Asked to be built by Rui

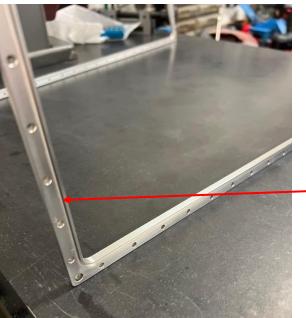
Do we need INSERTS???
WILL THERE BE ANY
PROBLEM WITH THE
ALIGNMENT: detectorframe-cathode?

Oring groove 2 mm wide 1.7 mm deep for 2 mm orings

(different from drawing on the right)
